•		
Form 3160-5 UNITED STATES (April 2004) DEPARTMENT OF THE INTERIOR BUREAU OF LAND MANAGEMENT			FORM APPROVED OM B No. 1004-0137 Expires March 31, 2007 5, Lease Serial No. Services Serial No.				
	Y NOTICES AND REP			6 If Indian, Allor			
DO NOT USE abandoned	this form for proposals t well. Use Form 3160-3 (API CONTRACTOR	WED.	ev if plants may			
SUBMIT IN T	RIPLICATE- Other instr	ructions on revers	e side.	7. If Unit or CAM	Agreement, Name and/or No.

1. Type of Well Oil Well O	Gas Welling Other	JUL 07	2011	8. Well Name and	1 No		
2. Name of Operator Charges Middentisent I. P. Farmington Field Office		eld Office	Rincon Unit #39 9. API Well No.				
3a, Address		Bureau of Land I 3b. Phone No. (include a	nea code)	30-039-0690			
·	15 Smith Rd., Midland, TX 79705 432-561-8600			10. Field and Prol, or Exploratory Area Blanco (Pictured Cliffs)			
· •	4 Location of Well (Footoge, Sec., T., R., M., or Survey Description)			11. County or Parish, State			
1647' FNL & 1516' FWL	UL F, Sec. 26-T27N-R7W 1647' FNL & 1516' FWL			Rio Arriba, NM

Attachment	to	notice	φĺ
Intention to	Ab	andon	:

Re: Permanent Abandonment

Rincon 39 Rio Arriba County, New Mexico Well Schematic

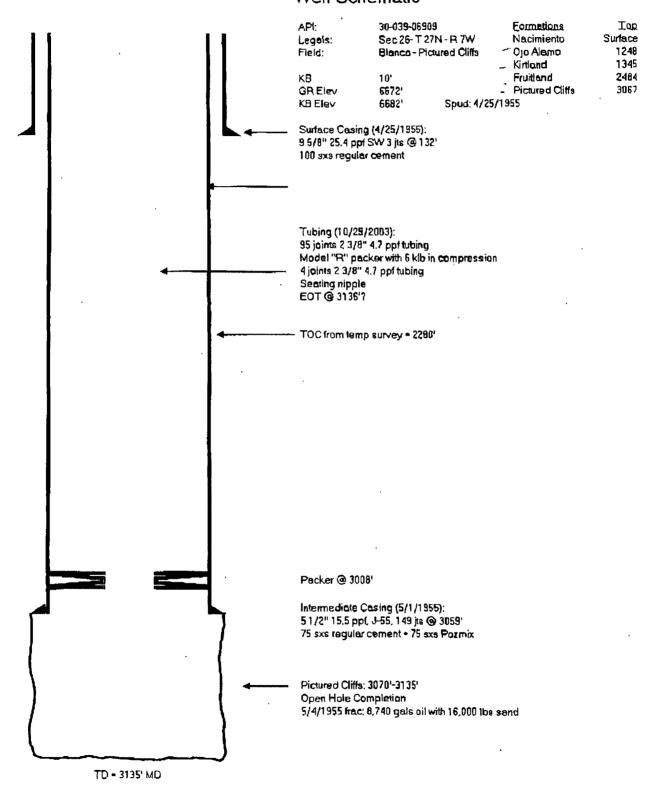
- 1. Plugging operations authorized are subject to the attached "General Requirements for Permanent Abandonment of Wells on Federal and Indian Lease."
- 2. Farmington Office is to be notified at least 24 hours before the plugging operations commence (505) 599-8907.
- 3. The following modifications to your plugging program are to be made:
- a) Place the Fruitland plug from 2858' 2758'.
- b) Place the Kirtland/Ojo Alamo plug from 2494' 2139'.

You are also required to place cement excesses per 4.2 and 4.4 of the attached General Requirements.
